TO: Mayor Jim Gilvin, City of Alpharetta
ATTN TO: Michael Woodman, Senior Planner, City of Alpharetta
FROM: Douglas R. Hooker, Executive Director, Atlanta Regional Commission
RE: Development of Regional Impact Review Finding

Name of Proposal: Continuum Alpharetta DRI 3508

Description: A DRI review of a proposal to build a mixed-use development on approximately 52 acres in the City of Alpharetta. The project site at 5555 Windward Parkway is bounded by Westside Parkway on the west, Windward Parkway on the north, and SR 400 on the east. Approximately two-thirds of the site is currently developed as two two-story office buildings with a large amount of surface parking. The other one-third of the site is currently wooded. The proposed development will consist of approximately 82 townhomes, 488 multifamily residential units, 218 hotel rooms, 1,028,500 SF of new office space, and 77,600 SF of restaurant/retail space. The roughly 517,399 SF of existing office space will remain. Approximately 7,900 parking spaces will be provided, of which about 7,620 will be in structured garages. Two wooded natural areas at the southern edge of the site will be preserved as wilderness parks with trails.

DRI SITE PLAN

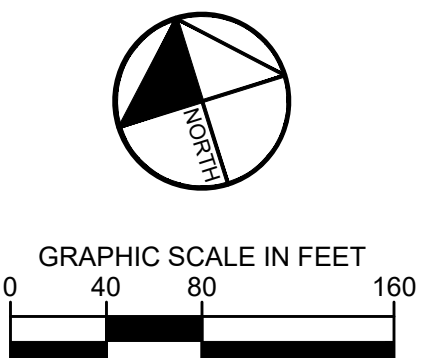
The wide breezeway in between the retail buildings at the NW corner of the site creates an inviting pedestrian access point; ideally it should extend all the way to the sidewalk at the Windward/Westside Parkways intersection. Widening of the sidewalk around this corner could further emphasize this important pedestrian connection and placemaking element. The intersection of the internal 12 ft wide trail with Westside Parkway provides a similar key pedestrian entrance and placemaking opportunity. Ideally there could be a third similar pedestrian access point/feature at Driveway D along Windward Parkway. The interior access road and perpendicular parking proposed along the Windward Parkway frontage seem more suited to a retail strip mall than to a large mixed-use development. Ideally this area could be revised to create a better street edge and pedestrian environment along Windward Parkway.

The 12-foot-wide multi-use trail linking the center of the site with the Windward and Westside Parkway frontages is a highly desirable aspect of the project. There are several opportunities for connecting this segment of trail within the project to the evolving nearby regional trails. There is a planned project to extend the Big Creek Greenway from its current access point at Marconi Drive and Windward Parkway to the intersection of Cogburn Road and Bethany Bend. This extension would cross Morris Road just north of Old Morris Road; from that point it would be short distance to connect to Windward Parkway and the project via the crosswalk at Driveway B. Another connection opportunity would be to the south from the Driveway A along Westside Parkway to Academy Street/Webb Bridge Road which is the site of the future outer loop segment of the Alpharetta Loop Trail. These short extensions would dramatically increase the span and connectivity of both the Alpharetta Loop and Big Creek Greenway trails.

The USGS coverage for the project area shows no blue-line streams on the project property. The submitted site plan shows two segments of a tributary to the blue-line stream crossing the project property. No intrusions are shown in the mapped buffers. Any intrusions proposed in these buffers may require variances. The proposed preserved natural areas around the stream tributary are highly in keeping with regional stormwater management, tree preservation, and carbon management goals. There are several areas on the plan noted as “stormwater management area” but seem to fall within a building footprint of the Block H and I parking decks. Ideally the parking can be reduced through the shared parking reduction option and the size of some the parking decks can be reduced accordingly.

The re-use of the existing large surface parking areas is also highly supportive of regional stormwater and redevelopment goals. There are large areas of existing trees that are proposed for clearing and development in the areas of Blocks D, J2, and K; ideally the bio-retention and parking area shown in the surface parking at Block D could incorporate existing trees. Additional retention of existing stands of trees would be desirable and in keeping with regional goals regarding carbon sequestration and climate change/heat island effect mitigation.
